Safety Recall K33

Power Steering Reservoir Cap

2010-2011 (DC / DM / DJ / D2 / DD / DP) Ram Truck

Figure 1 – Power Steering Reservoir Cap Location

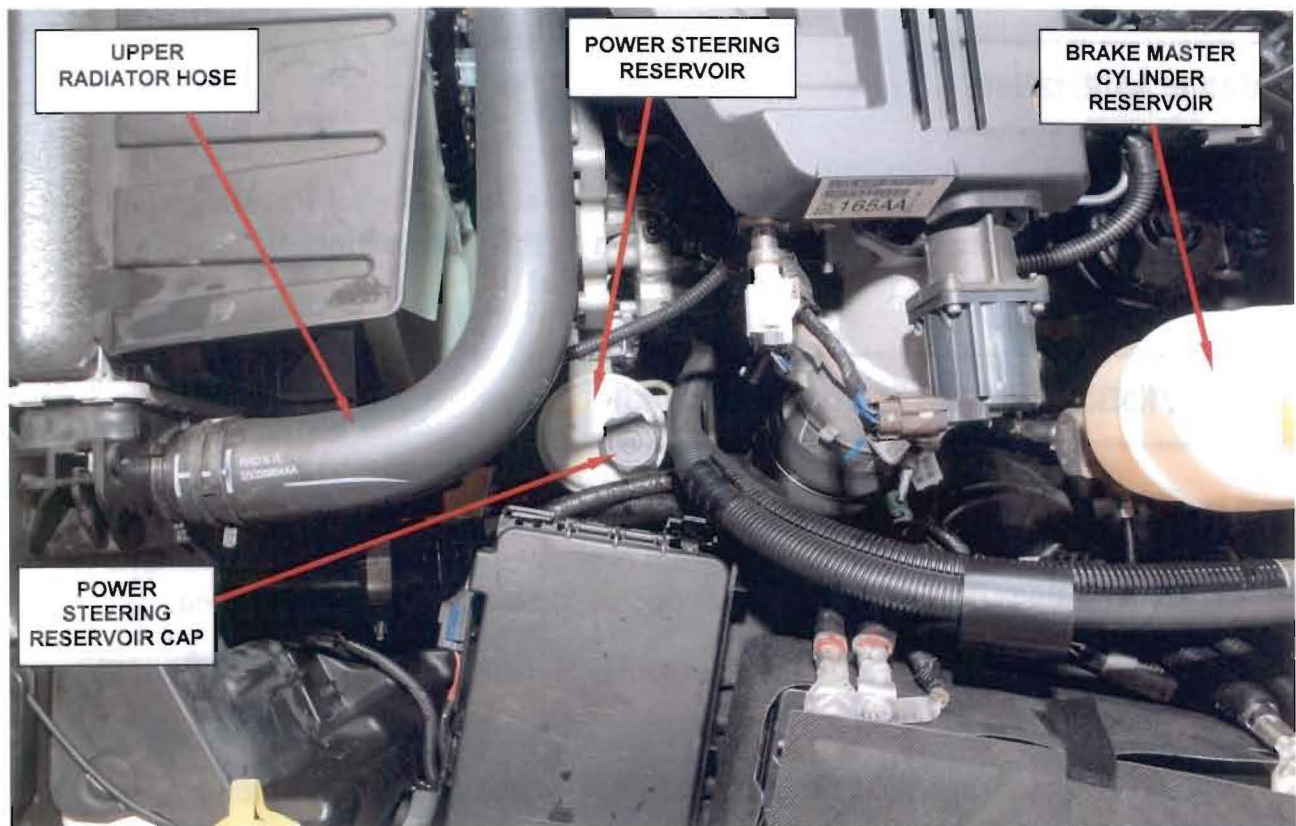
The power steering reservoir cap on about 62,000 of the above vehicles may cause excessive vent pressure levels in the power steering/hydraulic brake booster system. This may cause the vehicle to have brake lights that remain illuminated for an extended period of time after the brake pedal has been released. Brake lights that are slow to turn off could increase the risk of a crash.

The power steering reservoir cap must be replaced.

1. Open the hood.
2. Locate the power steering reservoir cap (Figure 1).
3. Using a shop towel, clean the area around the power steering reservoir cap to prevent dirt from entering the reservoir during the cap replacement process.
4. Turn the cap counterclockwise until it reaches the cap stop.
5. Lift the cap from the reservoir and discard the original cap.
6. Place the new cap into the reservoir opening and turn the cap clockwise until it reaches the cap stop.
7. Wipe off any power steering fluid that may have dripped onto the reservoir.
8. Close the hood and return the vehicle to the customer.
